The City of Norman, Oklahoma

## Historic District Commission Certificate of Appropriateness

REQUESTING THE FOLLOWING AMENDMENTS TO THE PREVIOUSLY APPROVED COA 24-08 AND 25-04:

W.W. HOUSE  
 1320 Oklahoma Av. Norman OK 73071

# 1- Modifications to the proposed patio and covered pergola

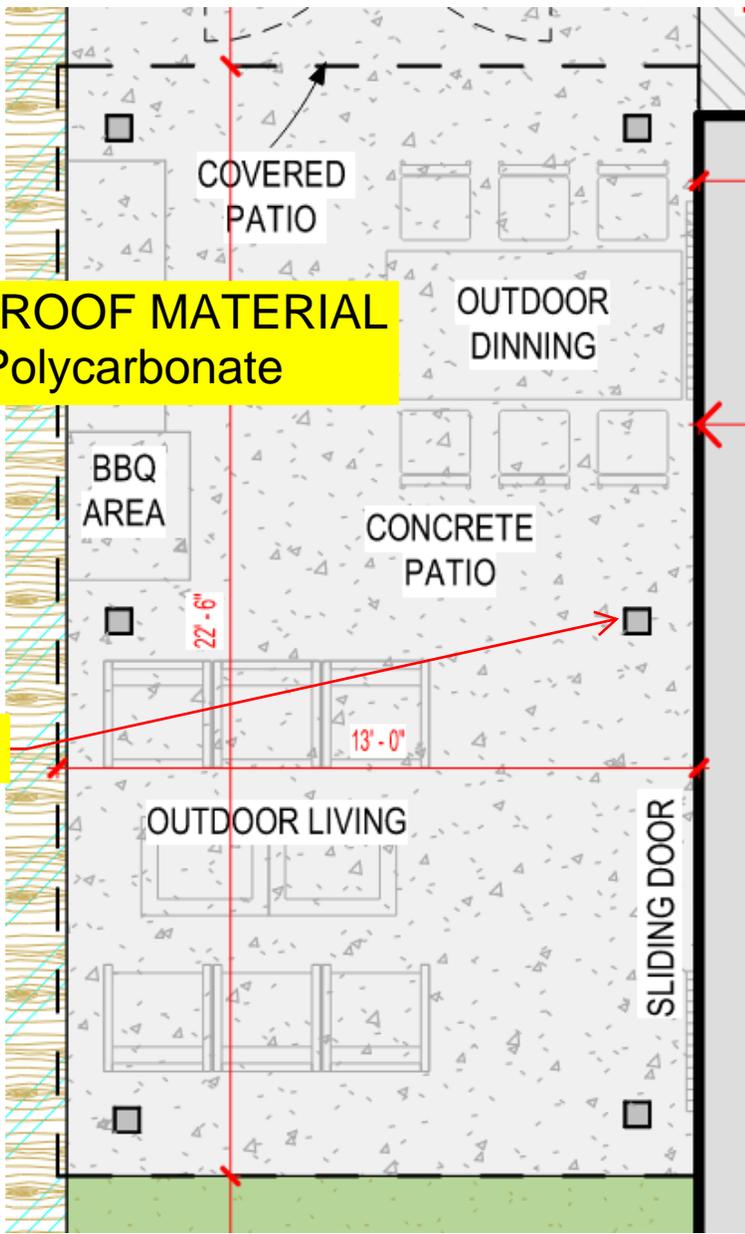
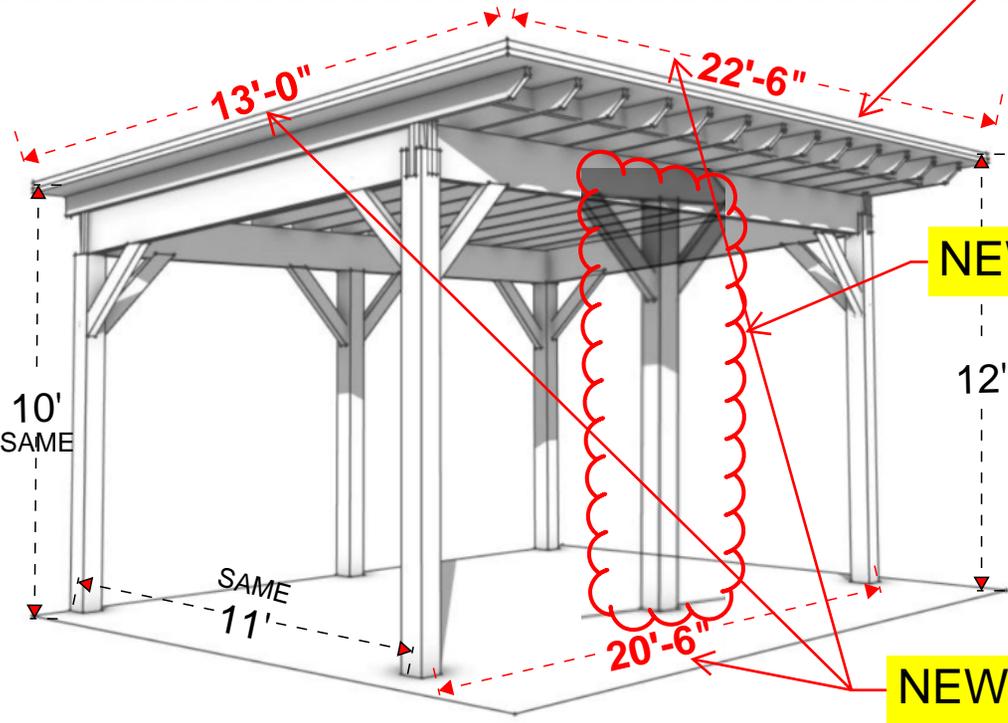
**+ NEW COLUMN AND SLIGHTLY BIGGER PATIO**

**+ ROOF MATERIAL UPGRADE**

No ADU allows more room for pergola

NEW ROOF MATERIAL  
Polycarbonate

NEW COLUMN

NEW SIZE

# 1- Modifications to the proposed patio and covered pergola

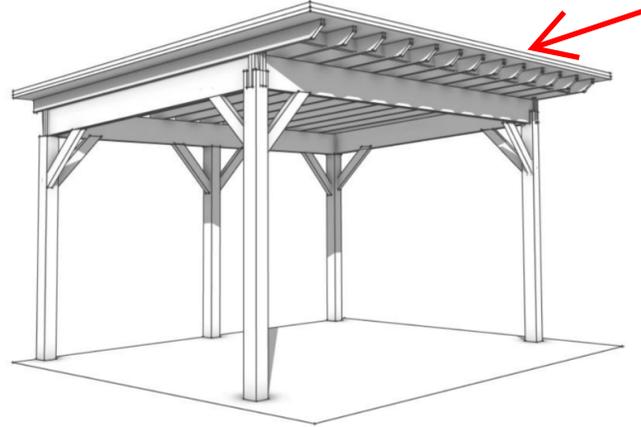
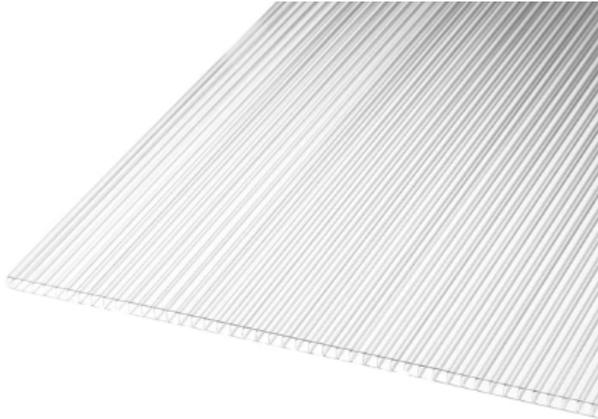
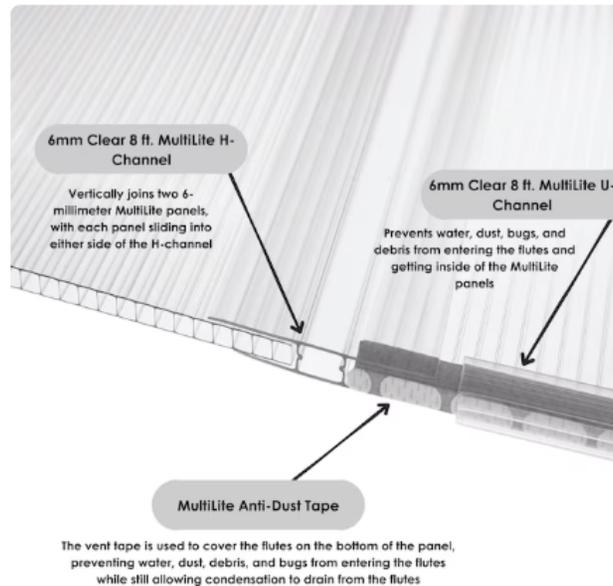
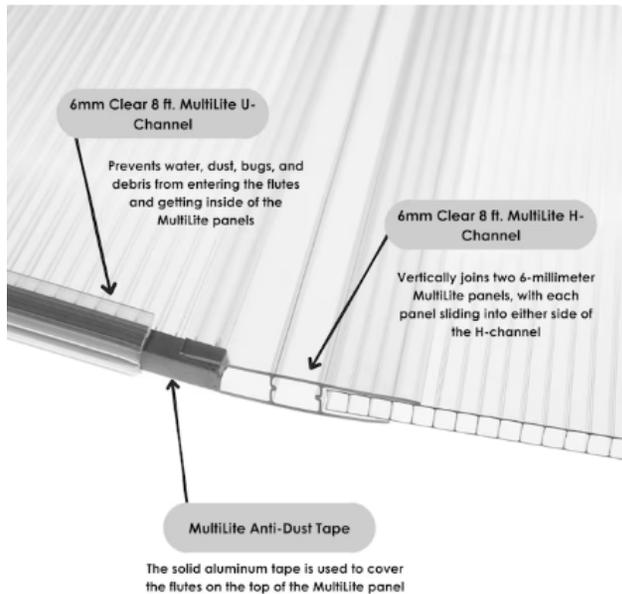
**NEW ROOF MATERIAL FROM ASHPALT SINGLES TO HIGH IMPACT POLYCARBONATE**

**Brand:** AmeriLux International  
**Ref:** MultiLite

**Size:** 4-ft x 8-ft Ribbed Clear Polycarbonate plastic Roof Panel

### 3- Extension of proposed retaining wall

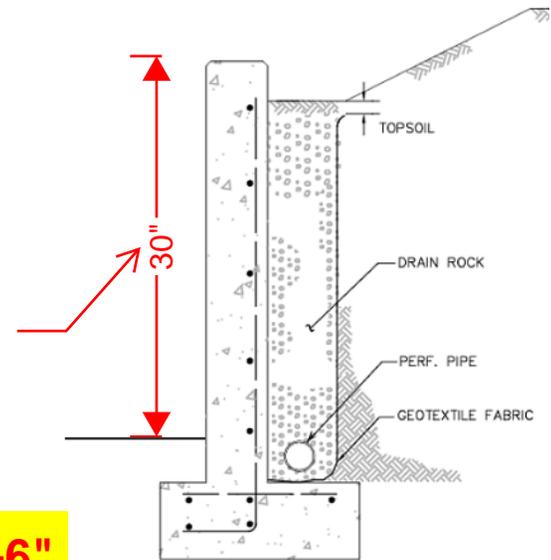
**Only visible from  
within property**

- + Concrete retaining wall**
- + Smooth finish**
- + Concrete footing**
- + Re-bar reinforcement**
- + 9" wide**
- + Concrete 3500 psi**
- + Chamfered edge for safety**
- + Same average height as previously approved, 30"**

# 3- Extension of proposed retaining wall

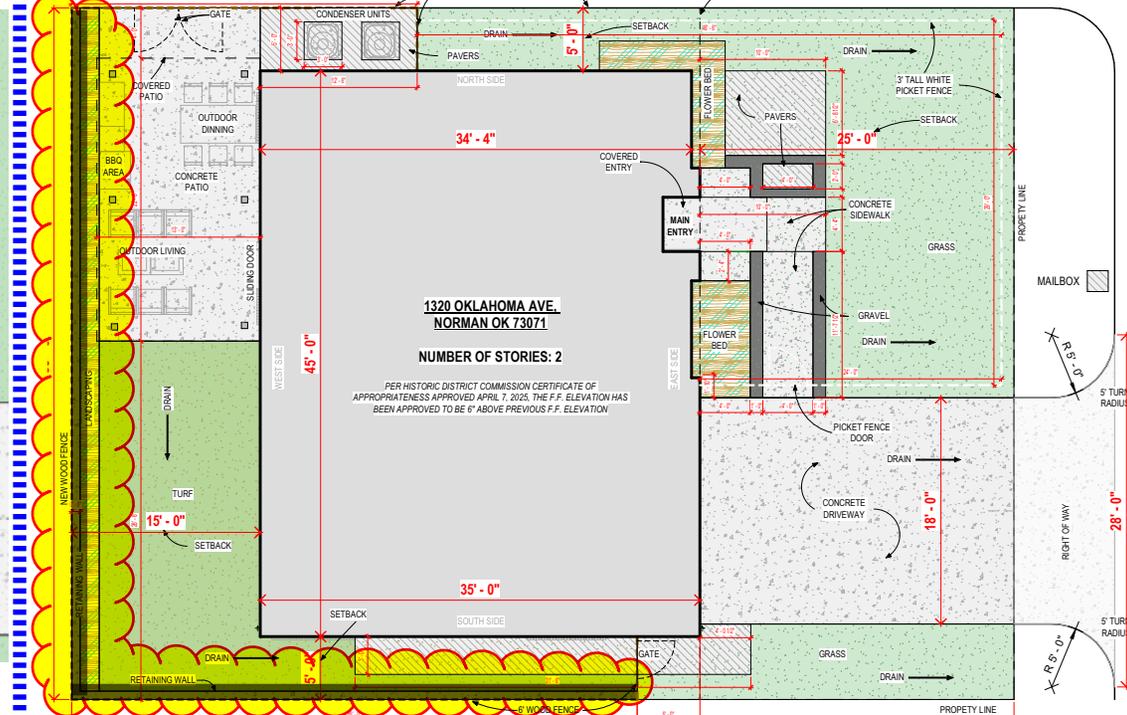
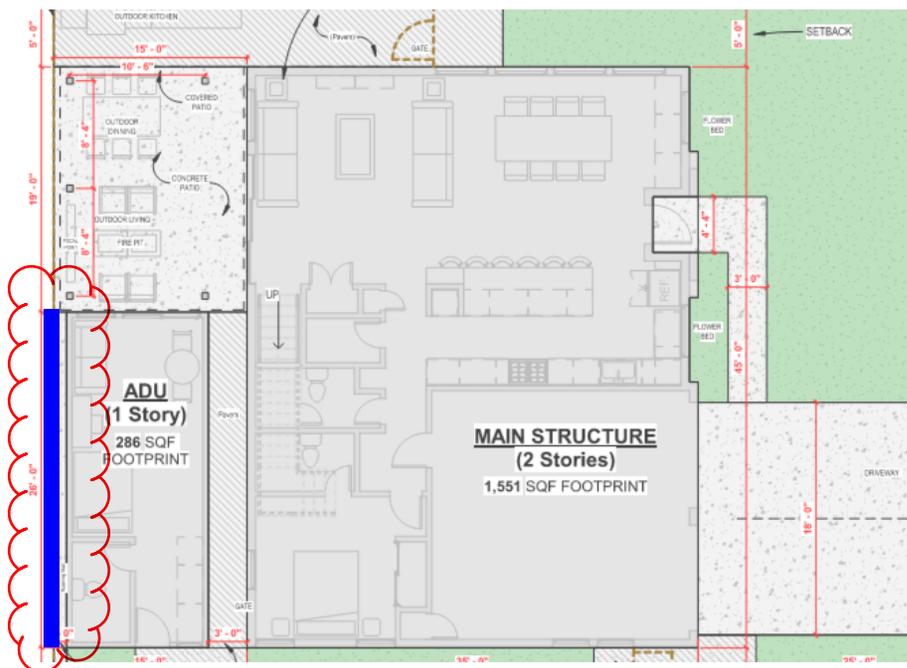
To mitigate water overflow flow the request is to **extend the length** of the retaining wall from **36 feet** to **105 feet**.

Average height over low ground **30"**

Prior approval = 36ft

New Requested L: 99'-6"

# 4-Upgrade exterior material to brick and stone

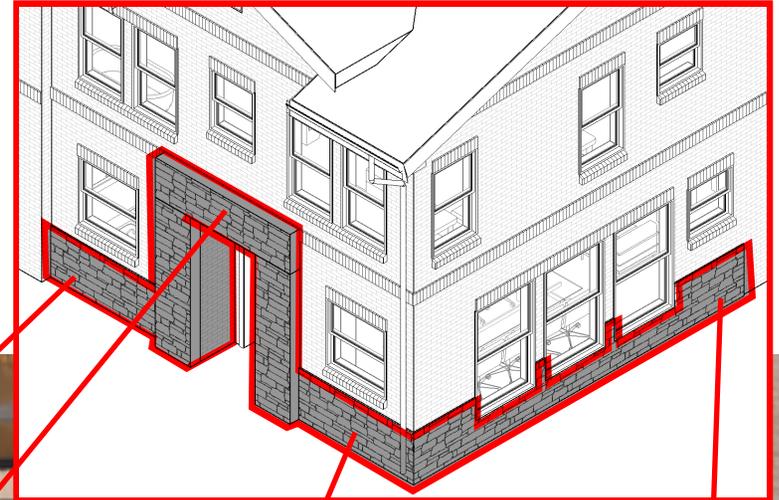
+ Entry portal from wood to stone  
+ Add wood base as shown

## 4-Upgrade exterior material to brick and stone

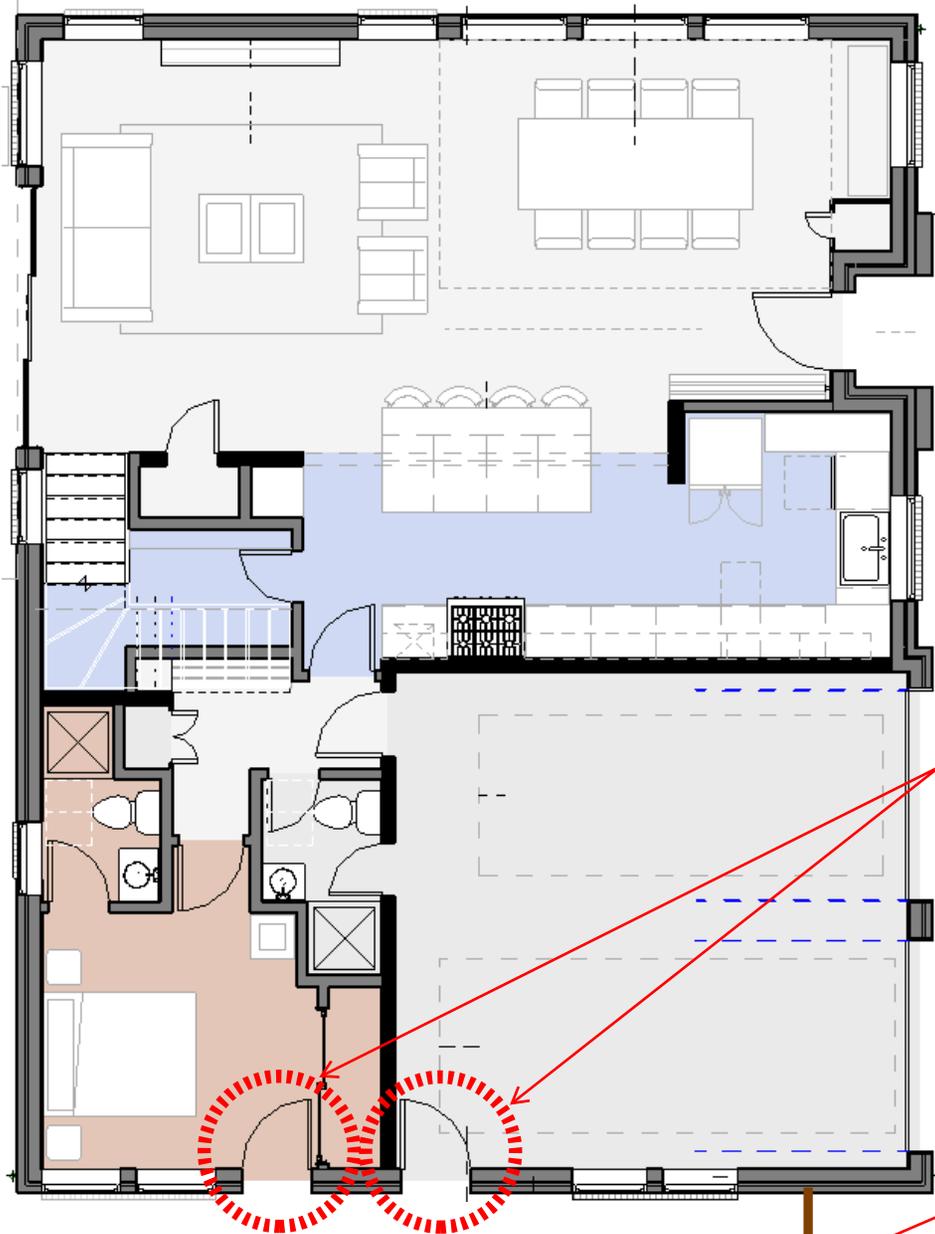
+ Using previously approved cedar wood, now the east windows will receive decorative cedar headers

# 6-Change proposed garage door design

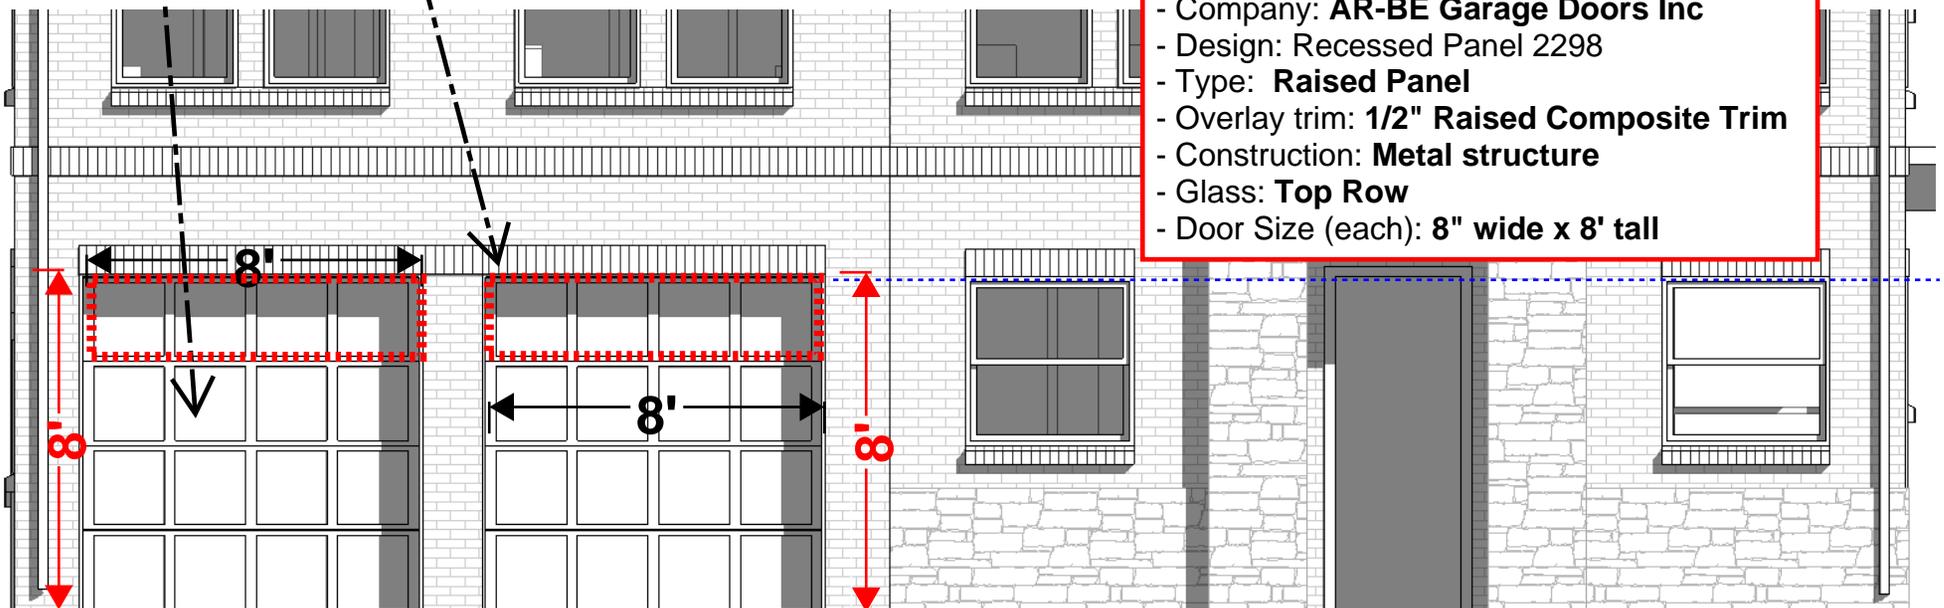
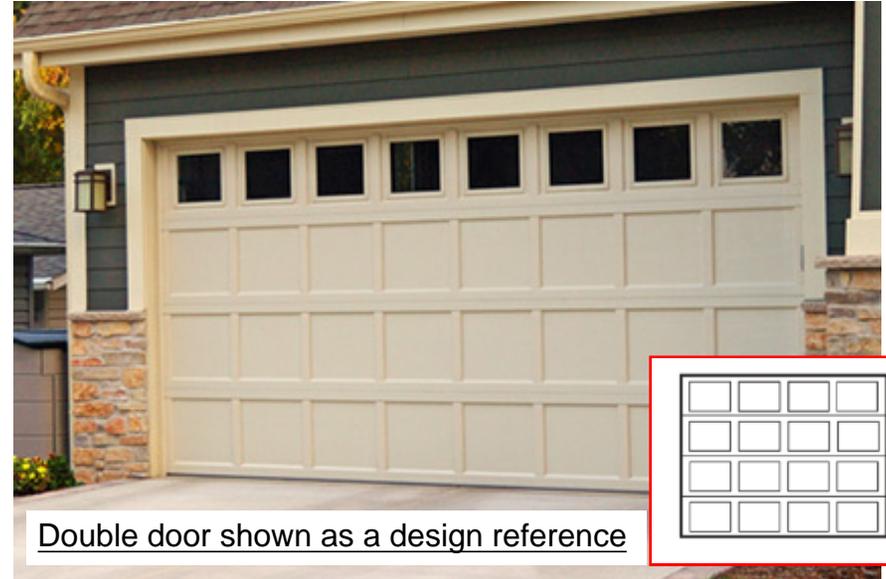
USING THE DOOR PREVIOUSLY APPROVED AS A BASIS OF DESIGN WITH **TWO UPGRADES:**

1- GLASS ON TOP ROW

2- INCREASE HEIGHT FROM 7' TO 8' TO MATCH WINDOW HEAD

# WEST ELEVATION - OLD

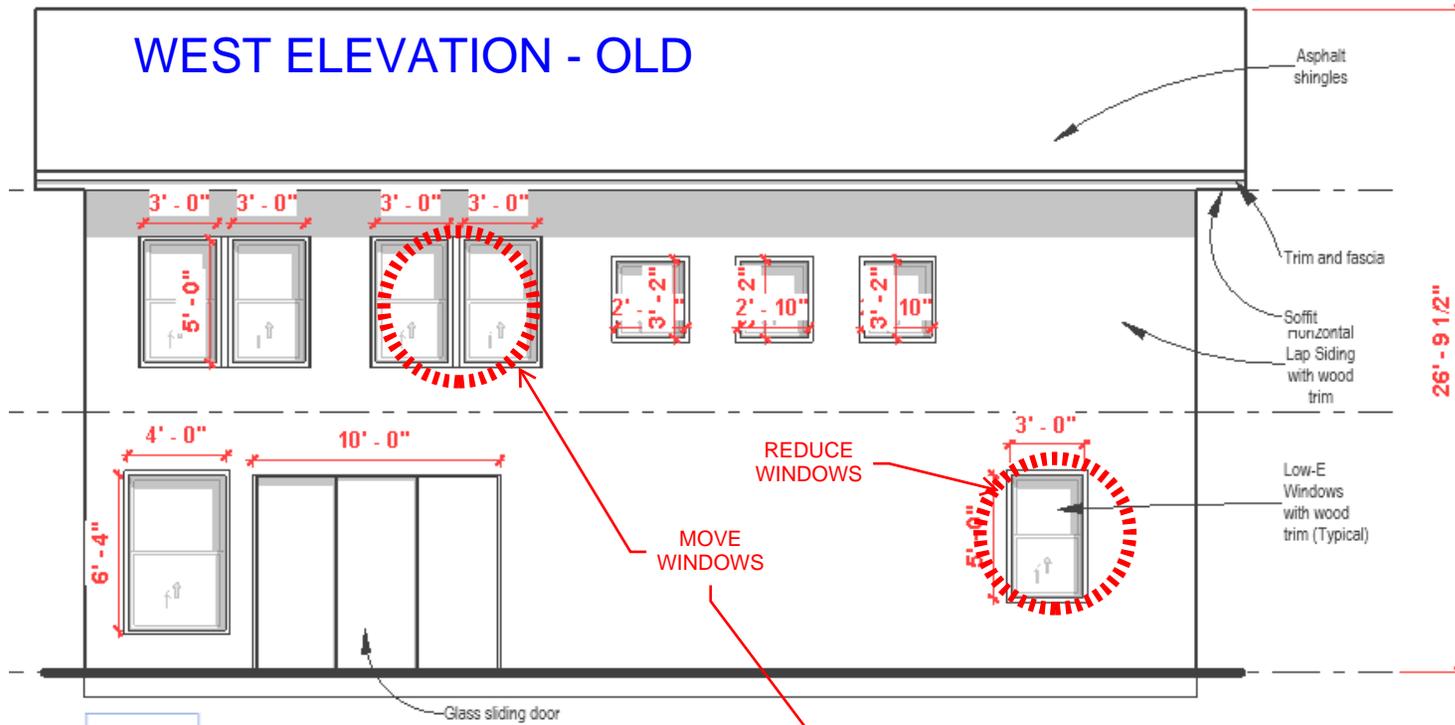
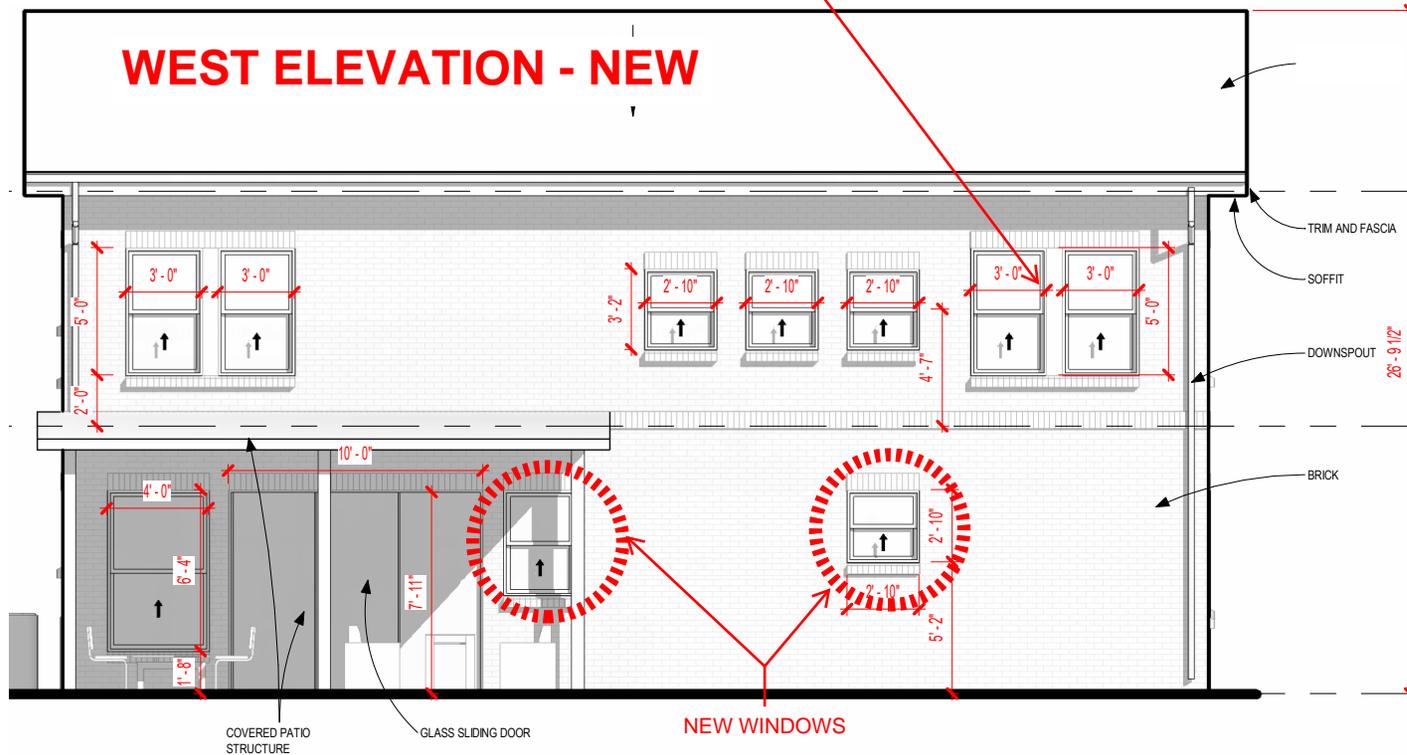
**+ ADDED 3 WINDOWS  
+RE-ORGANIZE OPENINGS  
+SELECTIVE SIZE CHANGES**
